From: Andrae, Bill/MKE [William.Andrae@jacobs.com]
Sent: 4/8/2021 4:50:47 PM
To: Mike Johnson [MJohnson@summitmetroparks.org]; bill.zawiski@epa.state.oh.us; Giancarlo, Mary Beth [Giancarlo.Marybeth@epa.gov]; Elaine Marsh [EMarsh@summitmetroparks.org]; Nick Moskos [nmoskos@summitmetroparks.org]; hullinger@akronohio.gov; pgsellman@akronohio.gov; Megan Shaeffer [mshaeffer@summitmetroparks.org]; Lisa King [LKing@summitmetroparks.org]; Deidre May [dmay@summitmetroparks.org]; Travis Saunier [tsaunier@summitmetroparks.org]; Ramsey Langford [rlangford@summitmetroparks.org]; Rob Curtis [rcurtis@summitmetroparks.org]
CC: Reif, Marty/WDC [Marty.Reif@jacobs.com]; Skwarski, Alison/DET [Alison.Skwarski@jacobs.com]; Gross, Carol [Carol.Gross@jacobs.com]; Crivello, Kristy [Kristy.Crivello@jacobs.com]
Subject: RE: Follow up from Site meeting March 30

From: Mike Johnson <mjohnson@summitmetroparks.org>
Sent: Thursday, April 1, 2021 6:22 PM
To: Gross, Carol <Carol.Gross@jacobs.com>; Crivello, Kristy <Kristy.Crivello@jacobs.com>; bill.zawiski@epa.state.oh.us; Andrae, Bill/MKE <William.Andrae@jacobs.com>; Giancarlo, Mary Beth <giancarlo.marybeth@epa.gov>; Elaine Marsh <EMarsh@summitmetroparks.org>; Nic

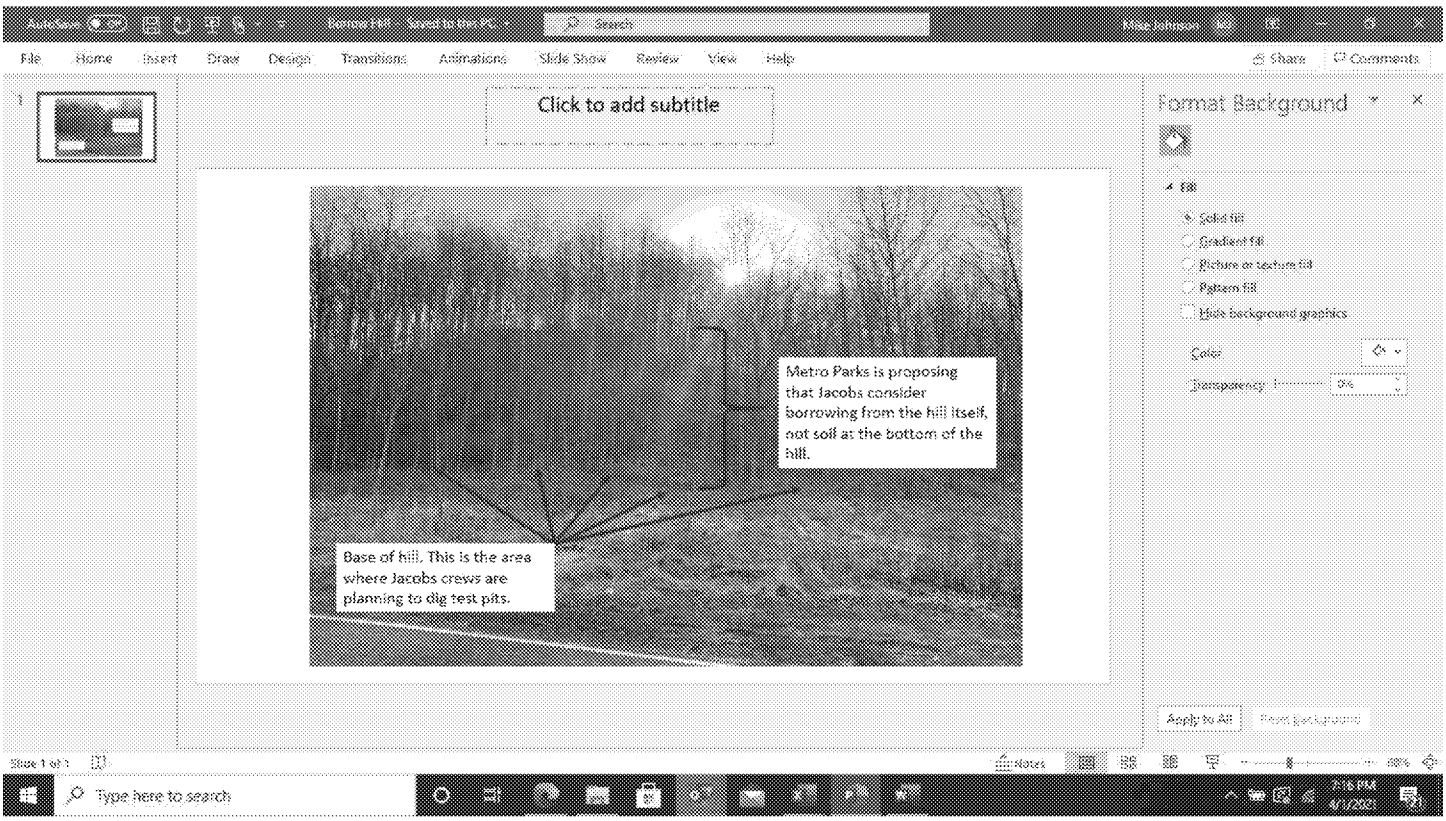
5. I do have one question in regards to the samples you are proposing to take from the potential borrow area. Summit Metro Parks suggested using soil from a nearby hill/slope that has been borrowed from in the past. We suggested taking from the hill and existing slope as shown in the picture attached. During the field meeting, you said that you wanted to take samples from the base of the hill below ground surface level. It seems counterintuitive that you would want to sample here. Is the plan to take soil from the hill or to excavate material at the base of the hill? Either may be OK as long as the material is suitable but we were originally thinking material from the hill above the surface, not excavated material from below the hill.

Hi Mike – We'd like to clarify our approach to the test pitting effort. The planned sampling approach will be to excavate into the slope from the base of the hill. Material will be harvested from the face of the slope up to the maximum reach of the equipment used. We will have the driller provide equipment capable of reaching up about 15 feet on the hill side slope.
